Town of Milford Meeting Notice

Board or Commission: Conservation Commission

Date and Time of Meeting: Wednesday January 20, 2021 at 7.00 P. M

OFFICE OF PLANNING
AND ENGINEERING

SHEET TITLE
CONSERVATION PLAN FOR LOT 1 & LOT 2 ARIANA CIRCLE

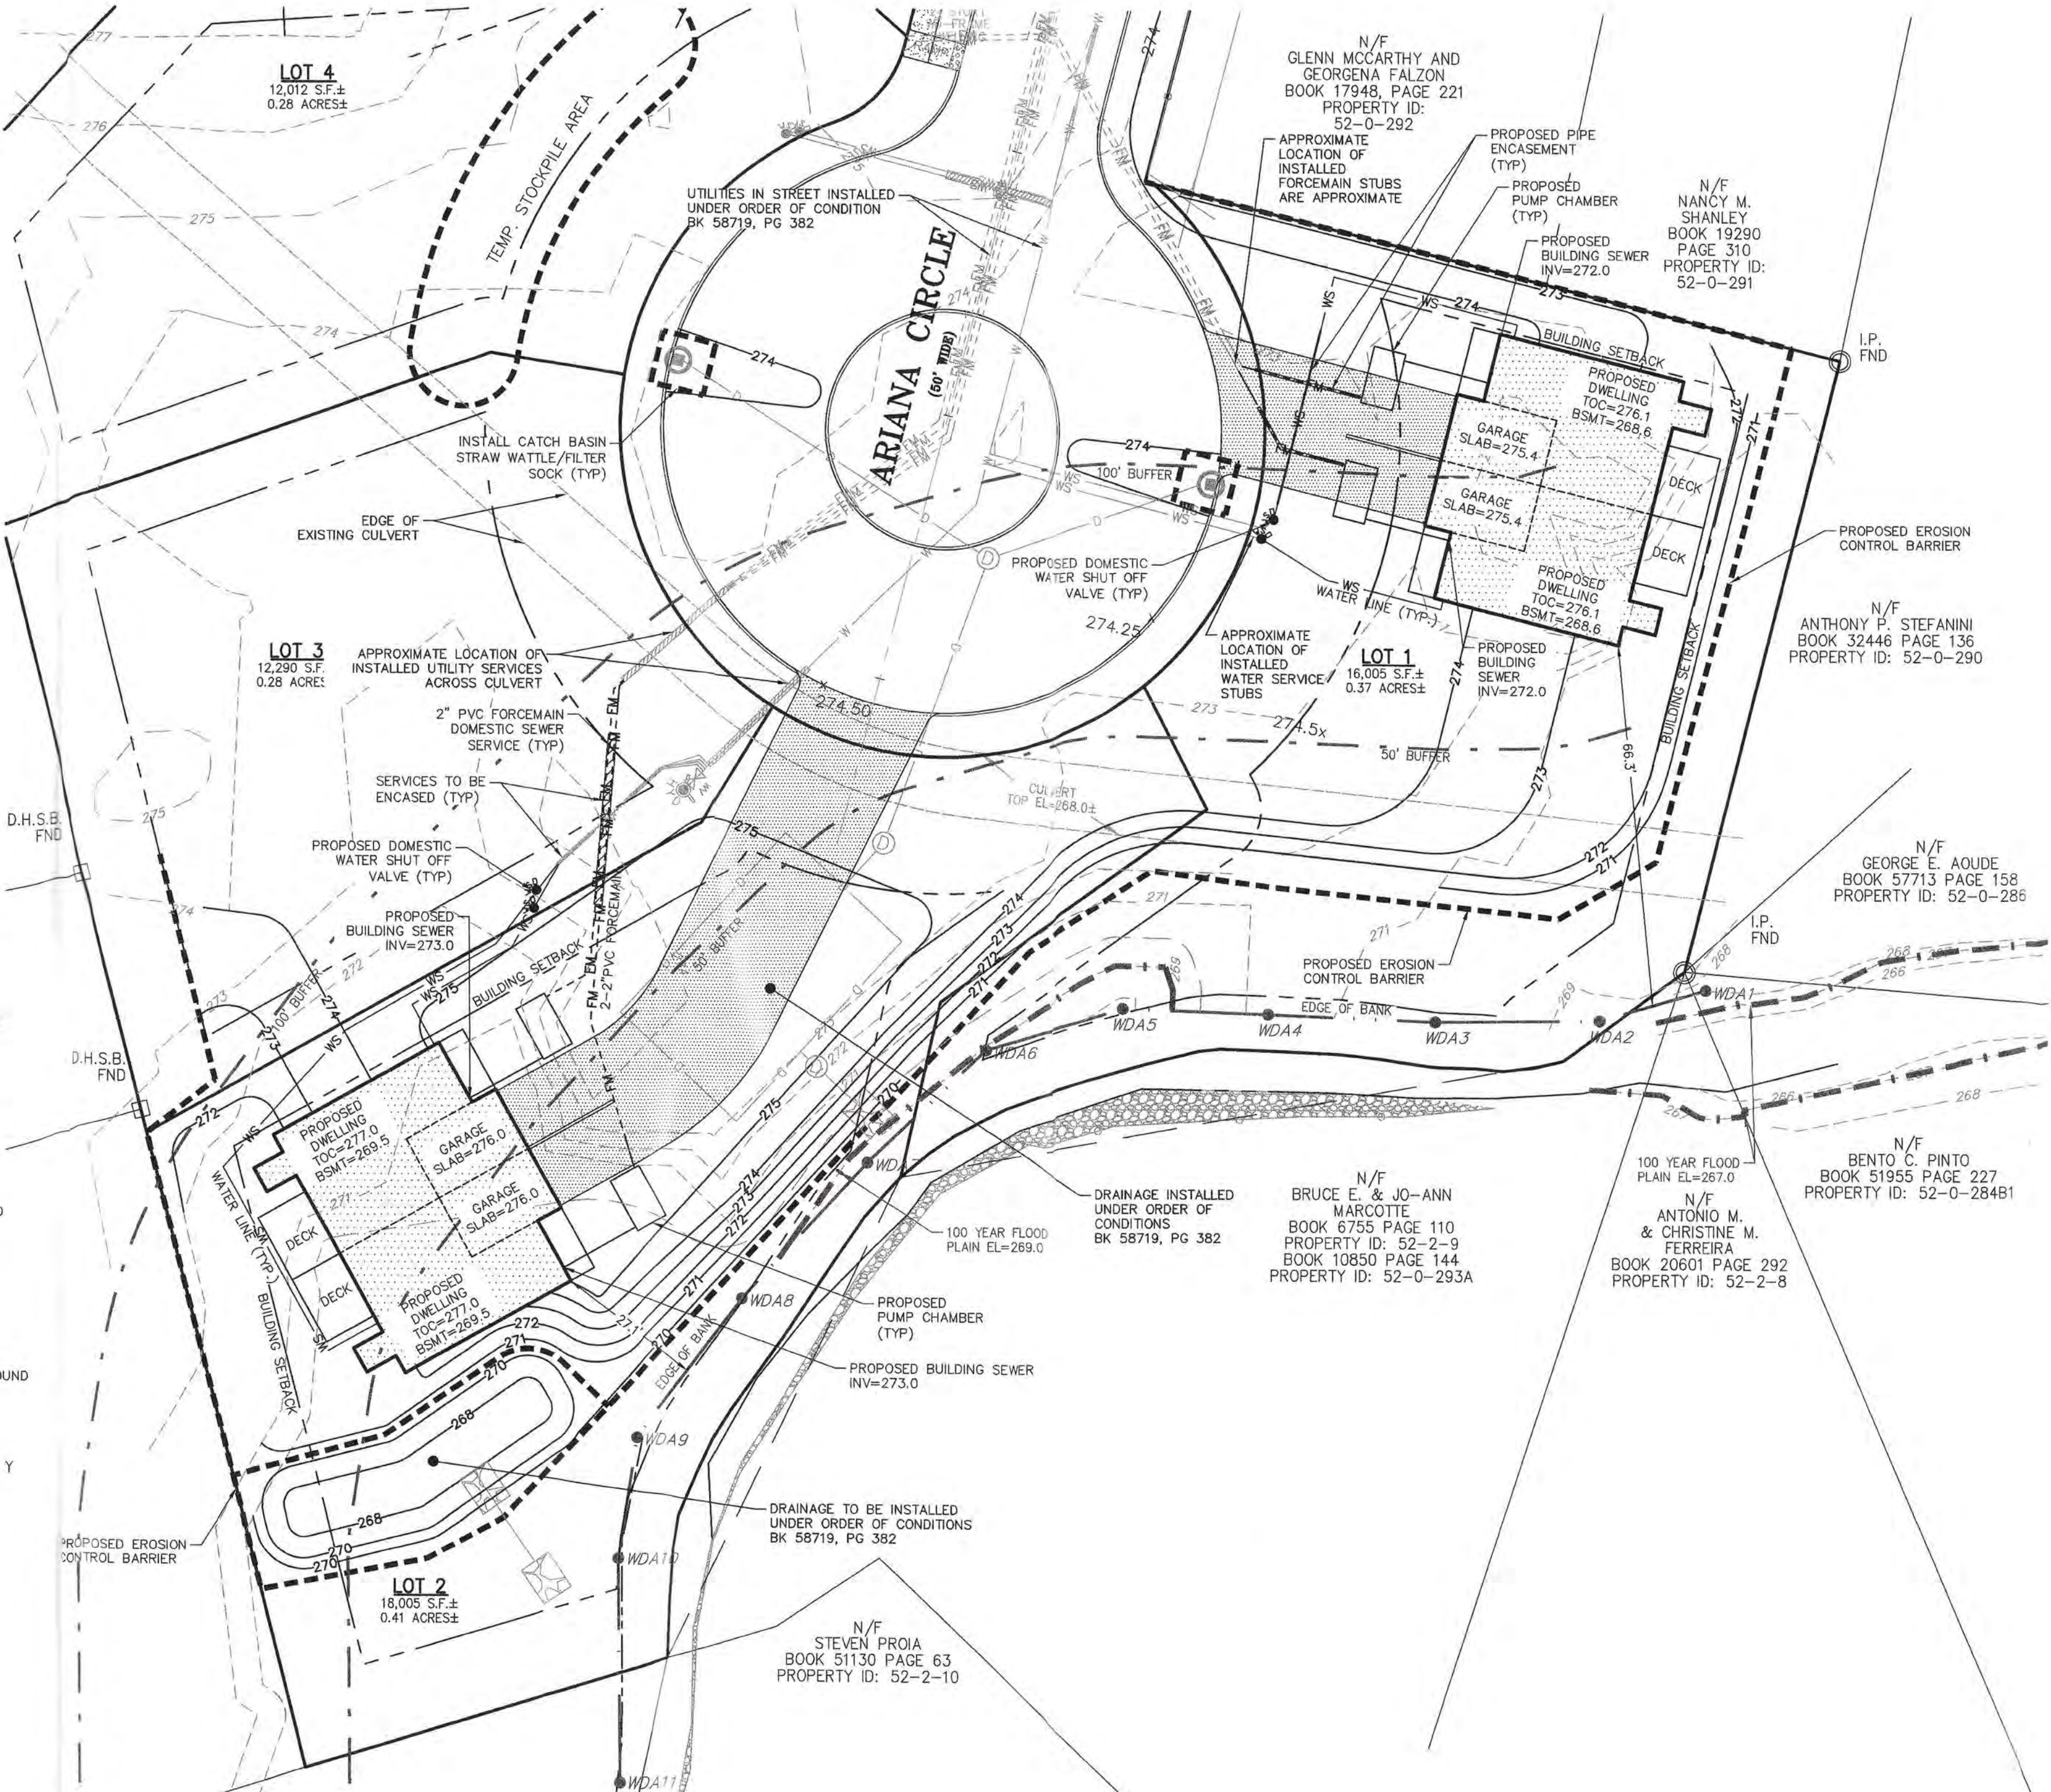
- The submitted plans (and previous subdivision plans) show some level of detail of the brook and what appears to be boulders along the edge of said brook. This detail work may possibly contain the information pertaining to the above referenced request by the commission (existing elevations of the brook and elevations of the abutting land on the south side of the brook). There may be a possibility that the original survey has the spot elevations of such detail work, this should be further researched and the elevations should be provided per the commission's request.

- The plans show a proposed driveway over the existing underground detention basin. The applicants engineer shall provide a detail of the **existing** basin with the proposed driveway and certify the **existing** underground basin is built to accommodate traffic loading (H-20). The detail should include items such as the type of the existing chambers, model number, the amount of crushed stone, amount of cover materials and type, etc.

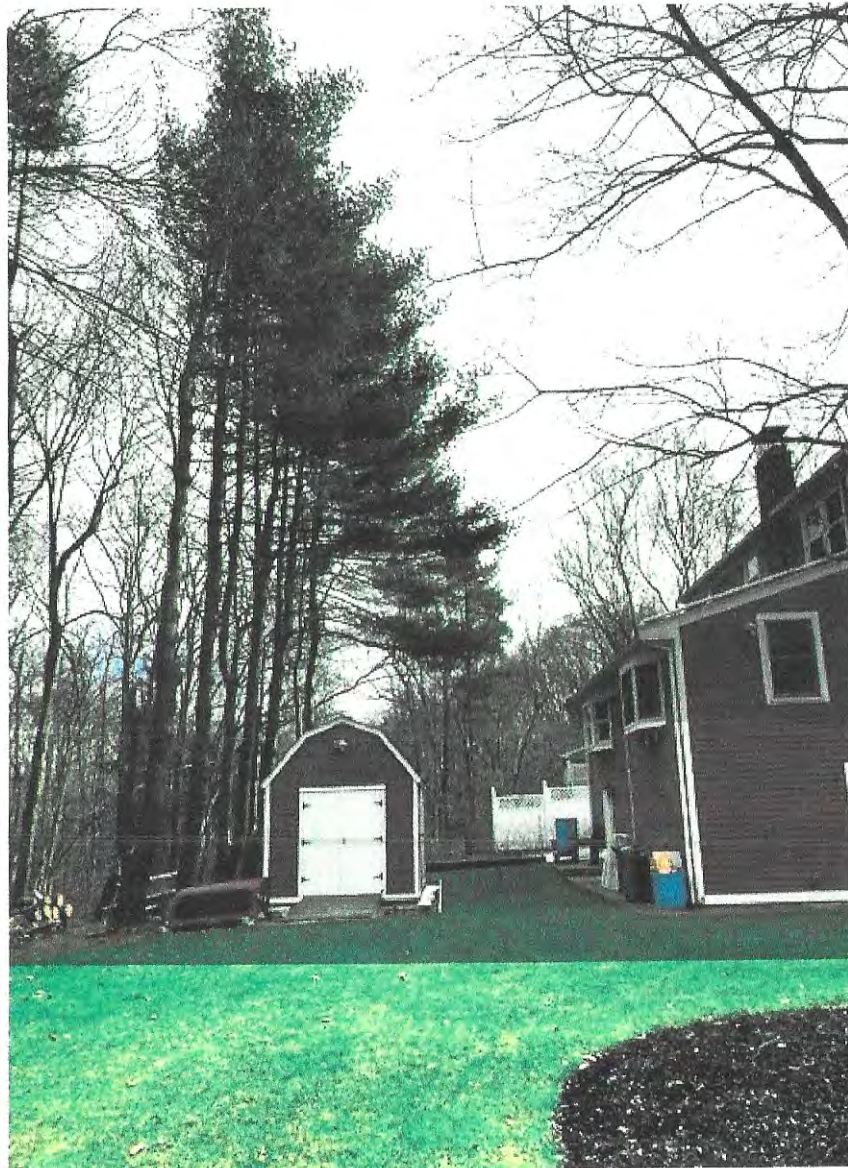
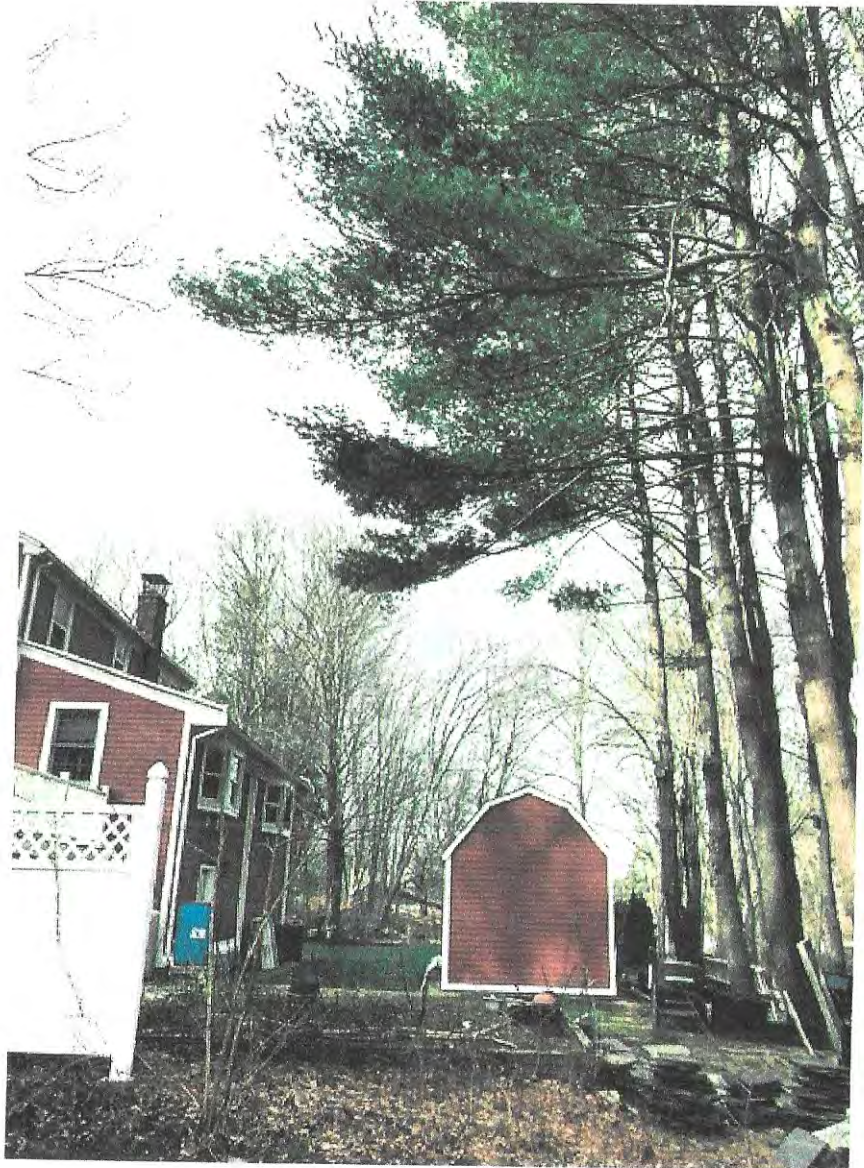
Following a review of the submitted documents and a site inspection, it is found that the five (5) trees are located in the rear yard and are in close proximity to the house. One of the 5 trees has sustained damage already. The canopy of the trees is essentially “one sided”, which is the side towards the house, posing more of a risk to the structure.

The pine trees were planted, they are not naturally occurring, as seen in the photos, they are all in a straight line. The closest distance to the wetlands is approximately 15-feet.

Erosion control should be installed if stump grinding activity is going to take place.

DEFINITIVE PLAN OF LAND
DEPOT STREET ESTATES
109 DEPOT STREET AND
75 FRUIT STREET
MILFORD, MASS.
SCALE: 1"=40'
DATE: MAY 26, 2020
REVISED: NOVEMBER 12, 2020

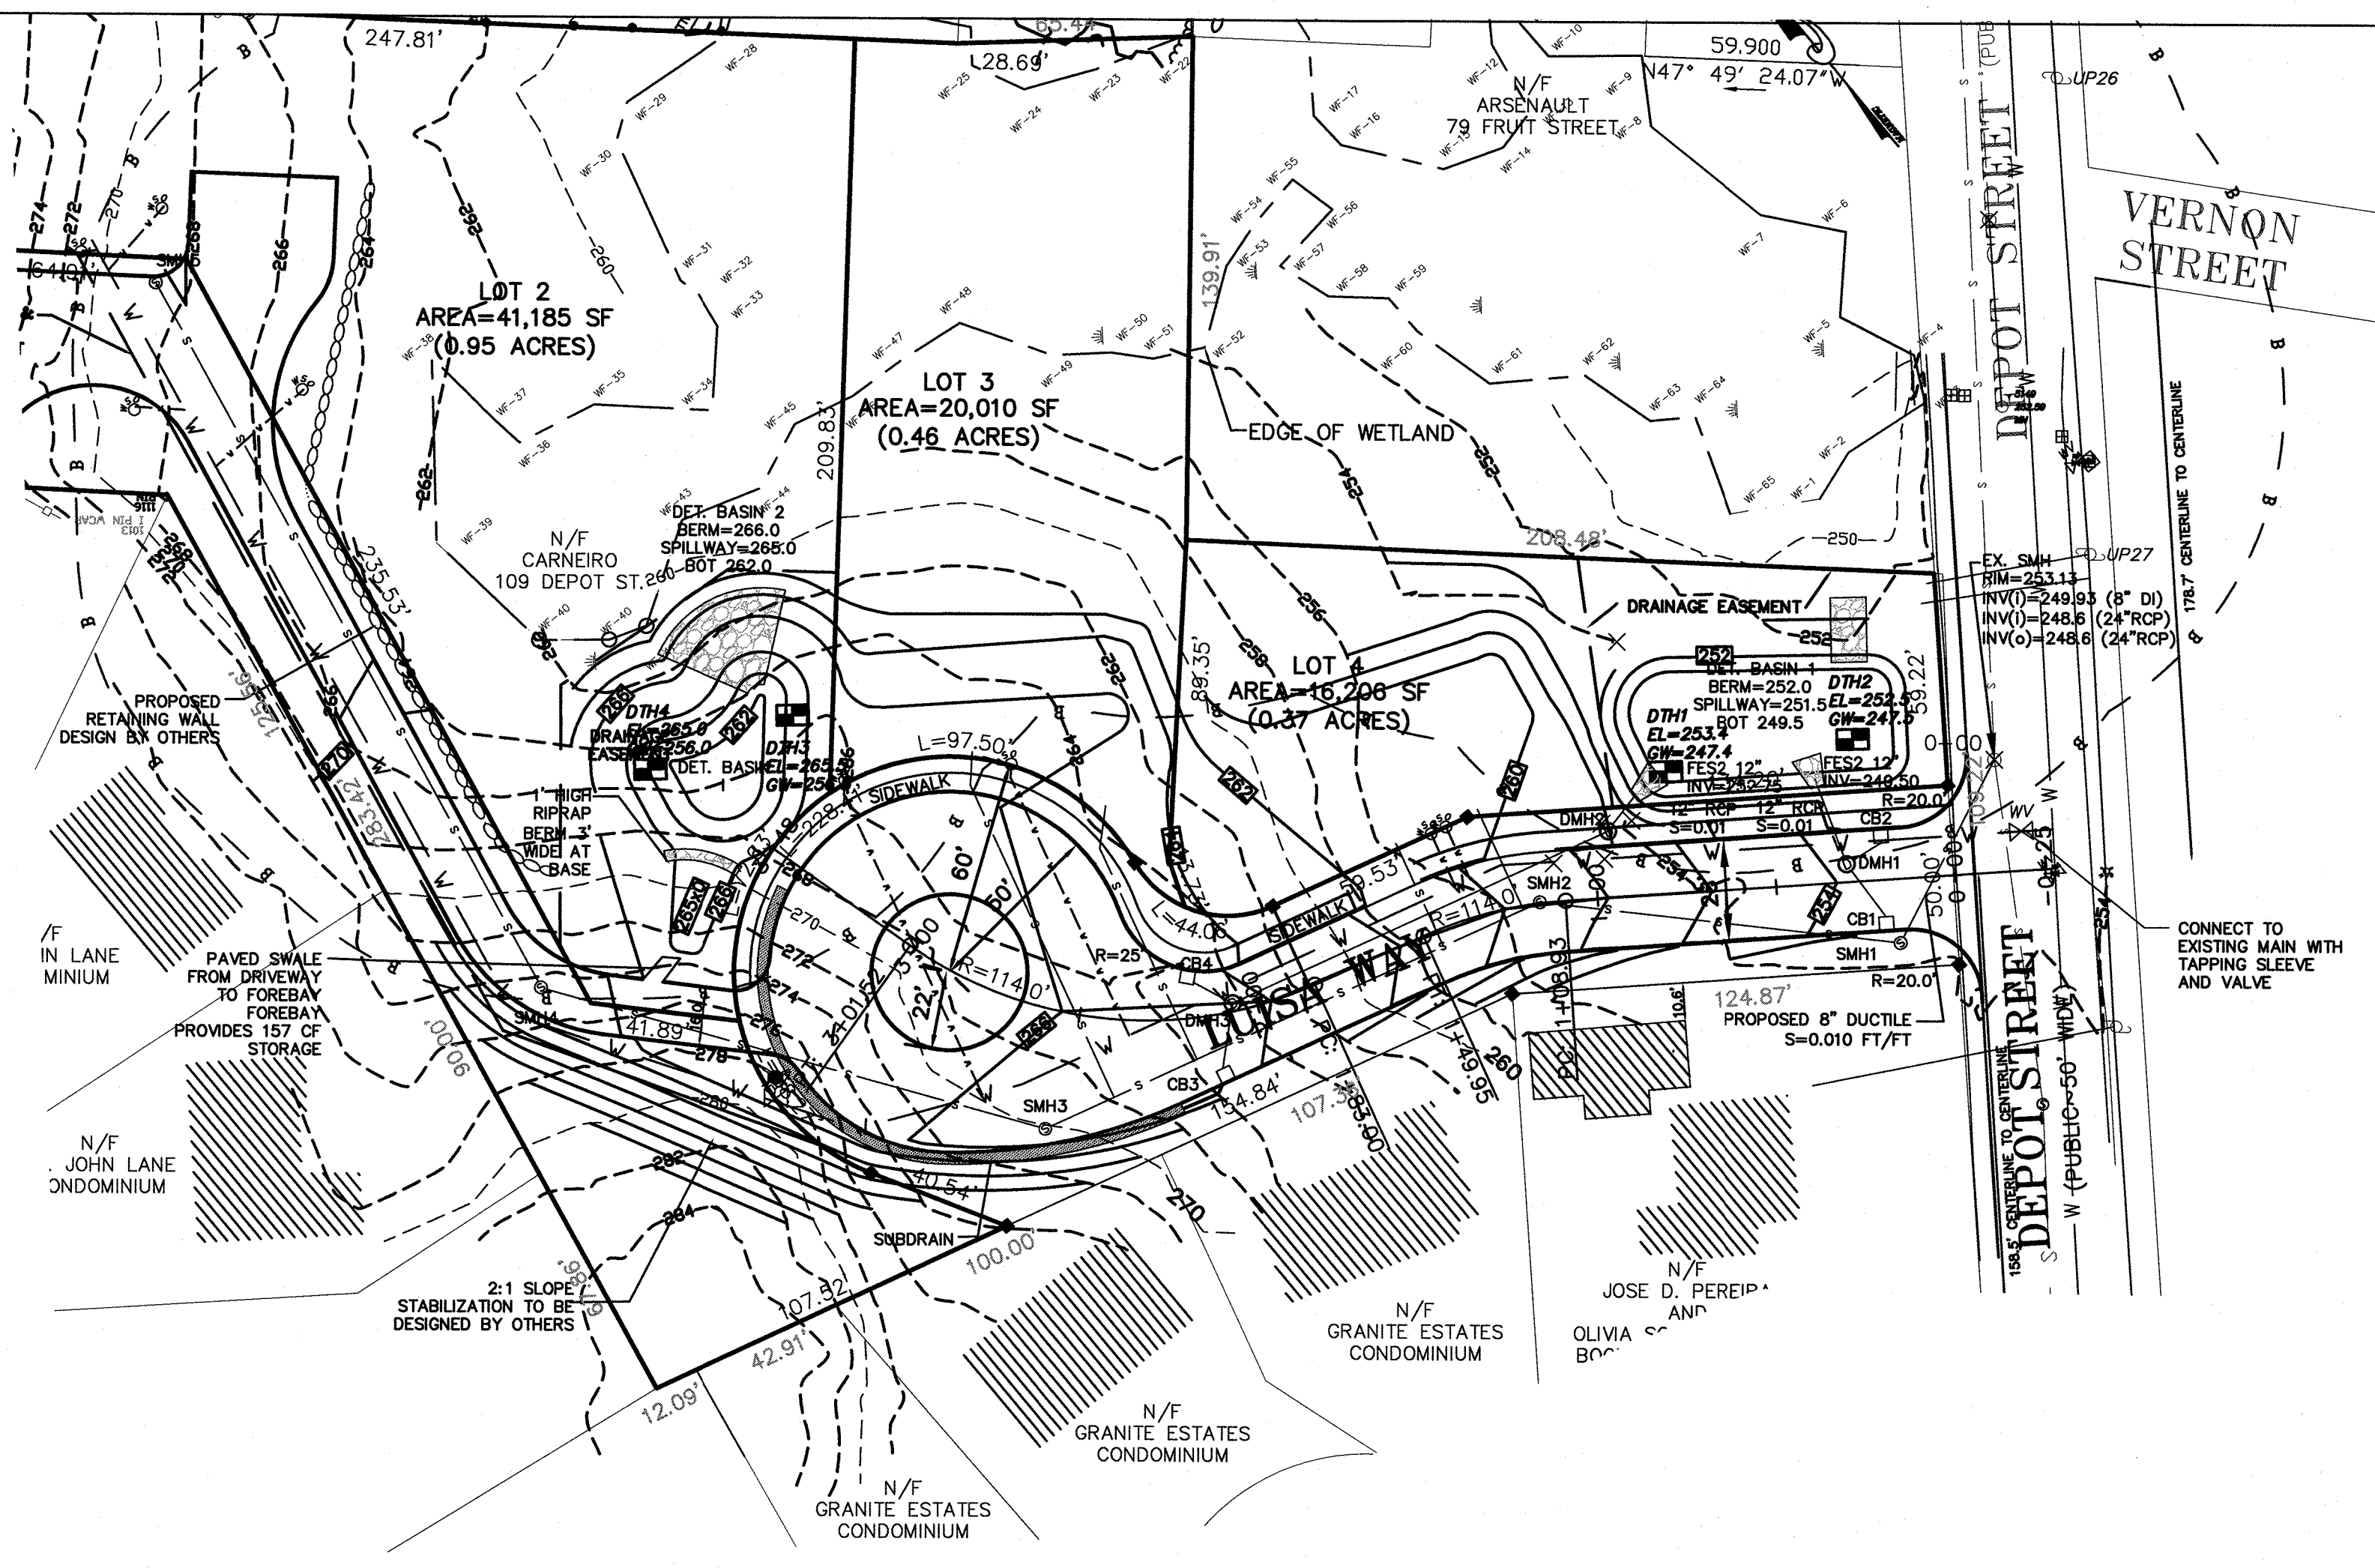
Following an additional review, I recommend that more detail be shown pertaining to the grading associated with the proposed driveway and swale, to ensure the drainage enters the swale and Detention Basin #2 as intended in the drainage design / analysis.
